November 2, 2016

**Reference: Sunoco Pipeline L.P. – Pennsylvania Pipeline Project  
Act 167 Stormwater/Floodplain Management Program Consistency Request-  
UPDATED Project Workspaces**

**Sheet 3** **Scale 1:2400**

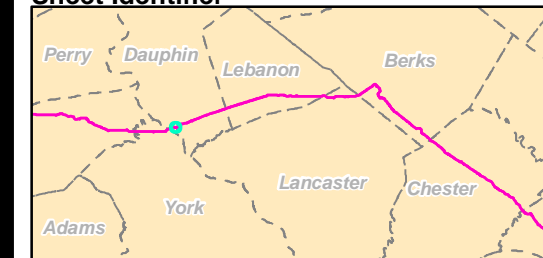
On behalf of Sunoco Pipeline, L.P., Tetra Tech, Inc. is writing to provide updated workspaces/floodplain maps associated with the Pennsylvania Pipeline Project (Project) in Highspire Borough as part of our Chapter 105 Water Obstruction and Encroachment Permit Application and request for Act 167 Stormwater/Floodplain Management Consistency Request. In a letter dated November 24, 2015, the Borough confirmed the Project's consistency with the Borough's stormwater/floodplain management program. Please find attached the latest Project mapping identifying the updated Project workspaces in your borough. The updated workspaces are highlighted as additions and subtractions. Note additional workspaces for construction and temporary access roads were required identified on Sheets 3-4.

Consistent with the letter we initially sent, no aboveground facilities or new permanent access roads are proposed in FEMA designated floodways or 100-year floodplains. The newly identified additional temporary workspace and temporary access roads are located within FEMA designated 100 and 500-year floodplains. However, these workspaces would be limited for construction use only and no permanent aboveground structures would be installed in these areas.
